**Calaveras County Water District  
Copper Cove, California  
Bidding Documents  
Copper Cove Water System Improvements Project – C-Tank Booster Pump  
Station Modifications and Transmission Main**

**ADDENDUM NO. 2  
Issued February 27, 2025**

FIGURE  
**C03**  
SHEET 5 OF 48

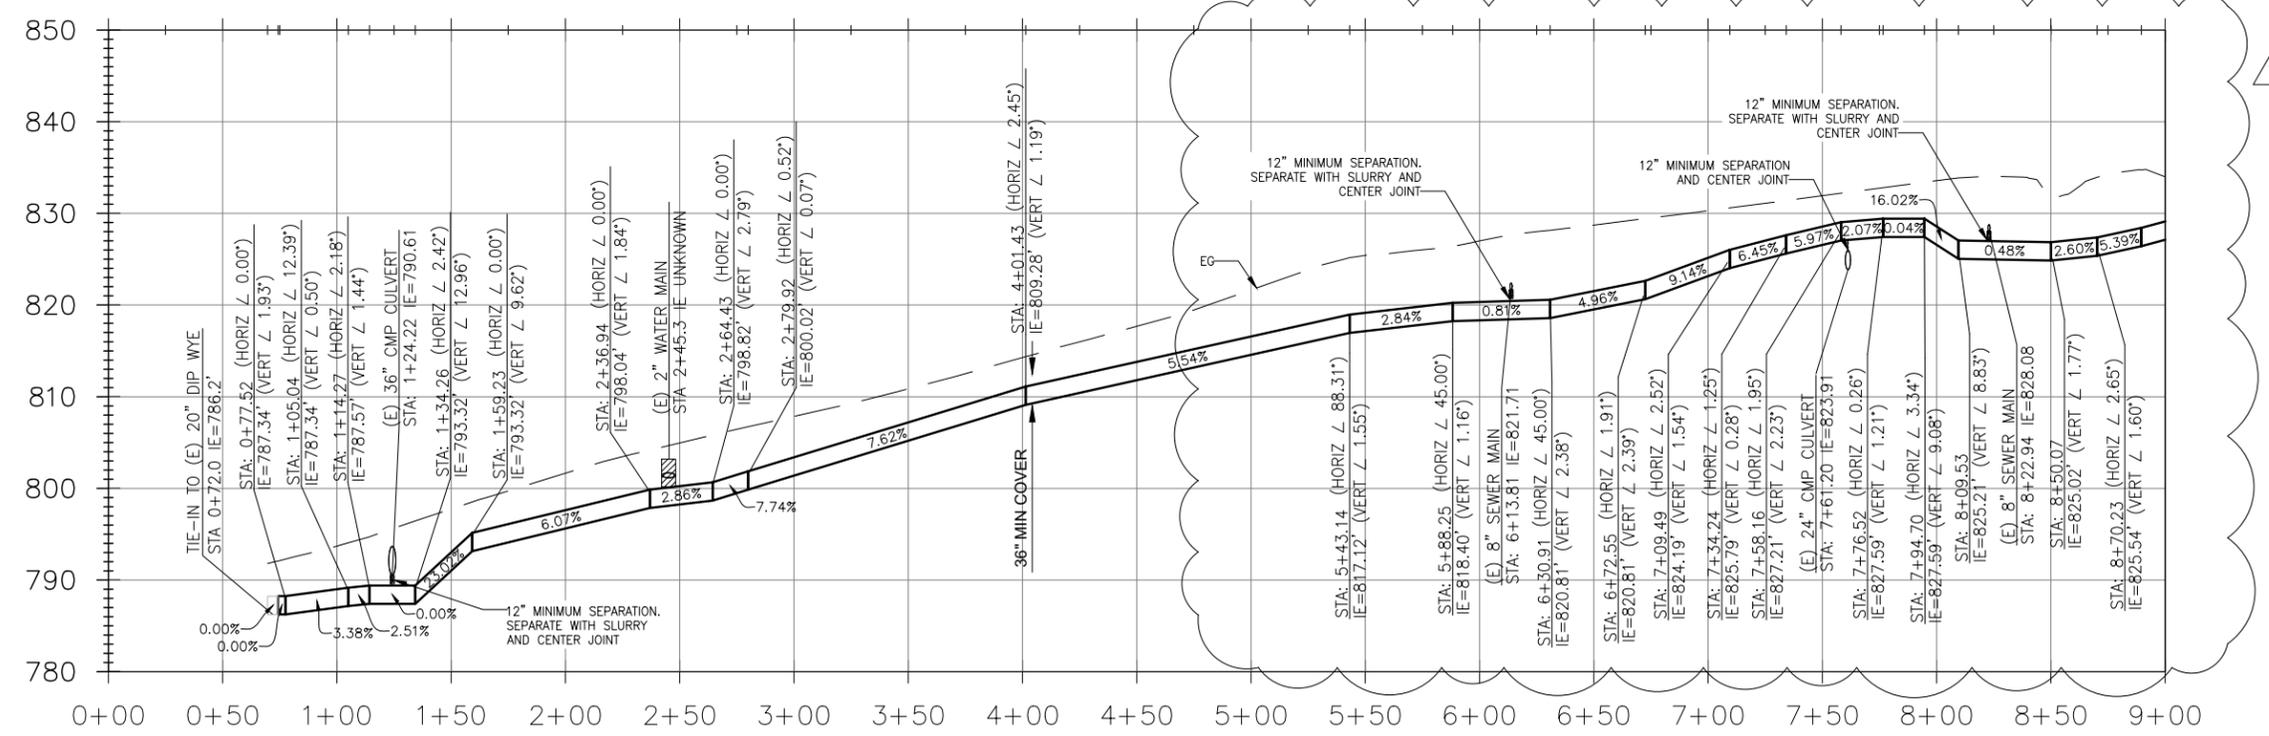
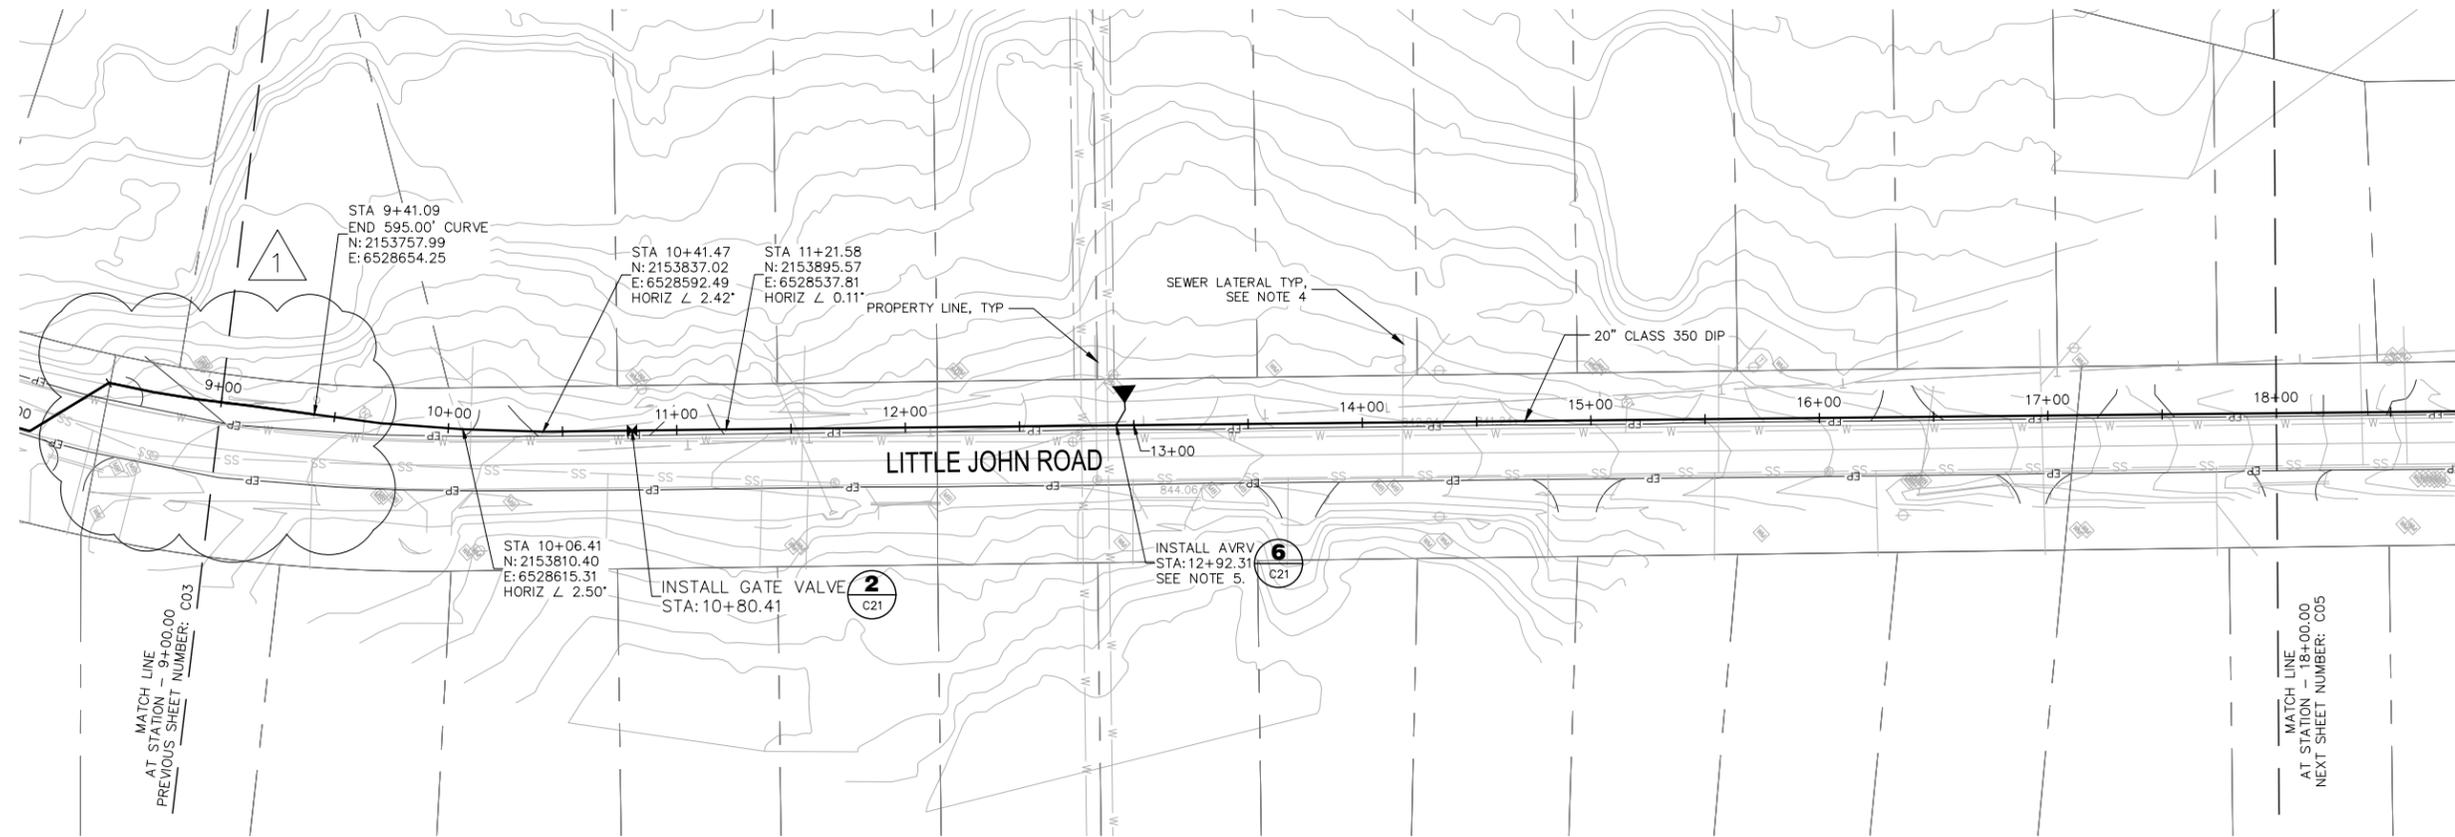
**Question #3: There are several sections along the proposed pipeline alignment (i.e. STA 45+00 to 53+00 and 6+00 to 9+00) where the centerline of pipe is shown approx. 2’-3’ off the EP. At these locations there is little to no shoulder with 8’-10’ drops off the roadway and steep slopes, which will not allow the minimum coverage horizontally due to the slopes and elevation changes. Is it the Engineer’s intent to build the embankment/shoulder out to achieve the coverage, move the alignment into the roadway and/or move the alignment to the toe of the slopes, or some other option? Please clarify.**

**Response #3:** The alignment has been revised, please see revised drawings in Attachment A. The paving quantities have been adjusted on the revised bid form in Attachment B. Engineer’s estimate has been updated to \$9.5 M based on revised quantities.

**IN-LINE BLOW-OFF VALVE**  
NTS

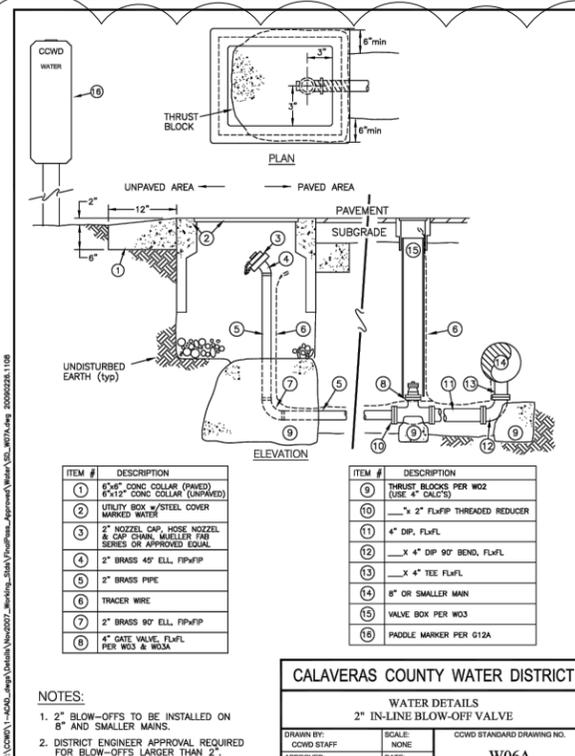
**Question #7:** There are several “blow-offs” shown along the pipeline alignment, as depicted in the Single Line Symbology”, and no Fire Hydrants. As there is no Blow-Off detail included in the plan set and not bid item for Blow-Offs, we are assuming these are representing the proposed Fire Hydrant locations, please confirm.

**Response #7:** The blow-off detail has been added to the revised drawings in Attachment A.
